Marine
Management
Organisation

Planning Inspectorate reference:
MMO reference: DCO/2013/00010

Non-Material Change Application to the Dogger Bank Creyke Back Offshore Wind Farm Development Consent Order 2015 (as amended)

Annex 1 – Bubble plots showing inter-annual variations in larval densities.

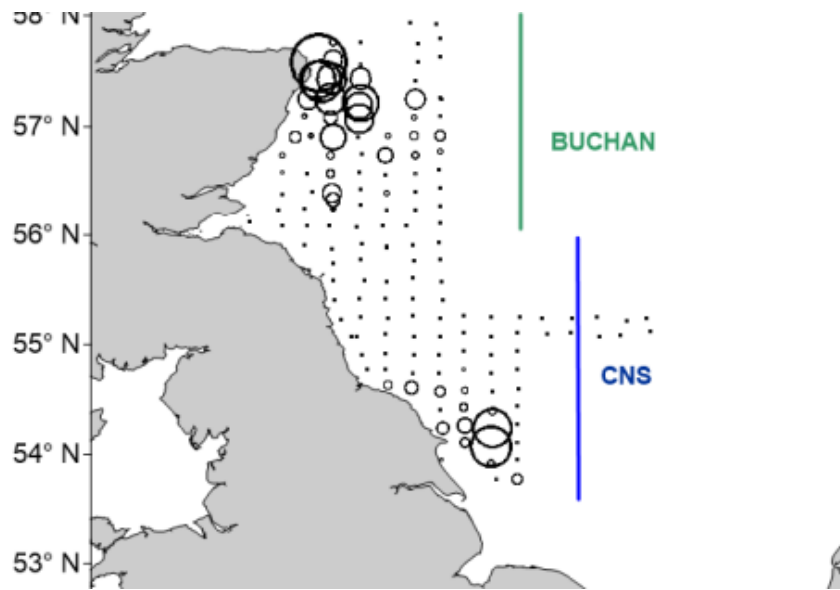
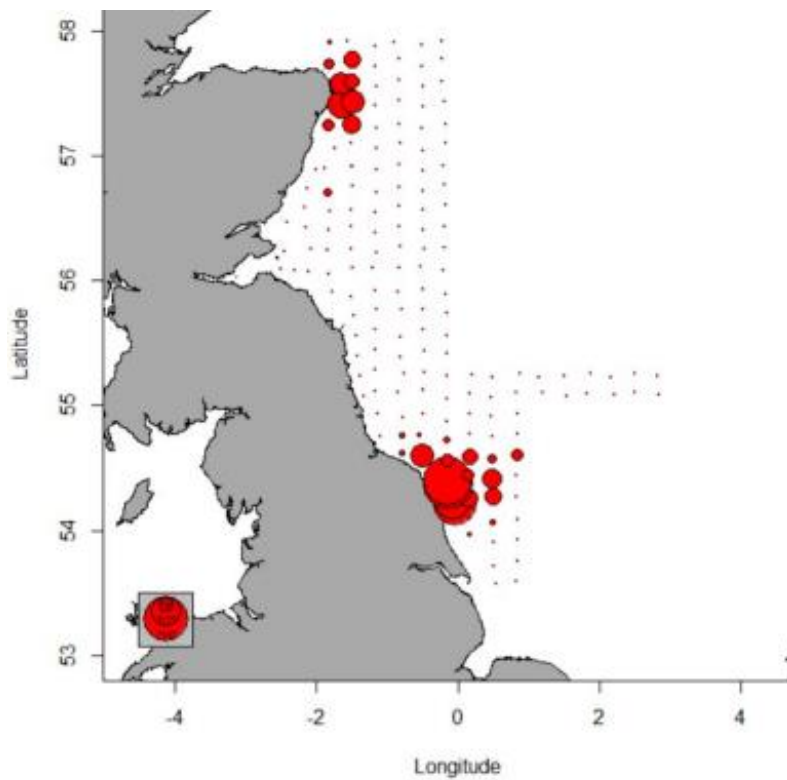
2. The Applicant has stated that the Projects are located '*approximately 80km from the high-density spawning grounds*' for Herring, however, it is unclear what data or maps have been used to support a distance of 80km and no supporting information has been provided to contextualise the definition of '*high-density*'. Herring do not exhibit spawning site fidelity and the locations of Herring spawning activity are known to vary year on year (see Annex 1 for ICES plots which demonstrate this point), therefore the distance between the Banks Herring spawning ground and the project will also vary inter-annually. The MMO would have expected the Applicant to have used International Herring Larval Survey (IHLS) data to support their assessment, for example, by providing a visual representation of Herring larval densities for the Banks Herring stock over a 10-year period, typically the data are presented in the form of a 'heat map'. The heatmap can then be overlaid with the piling noise contours from the modelling, to show the range of effect from noise in relation to larval densities. IHLS data can be downloaded from [Eggs and larvae \(ices.dk\)](http://ices.dk).
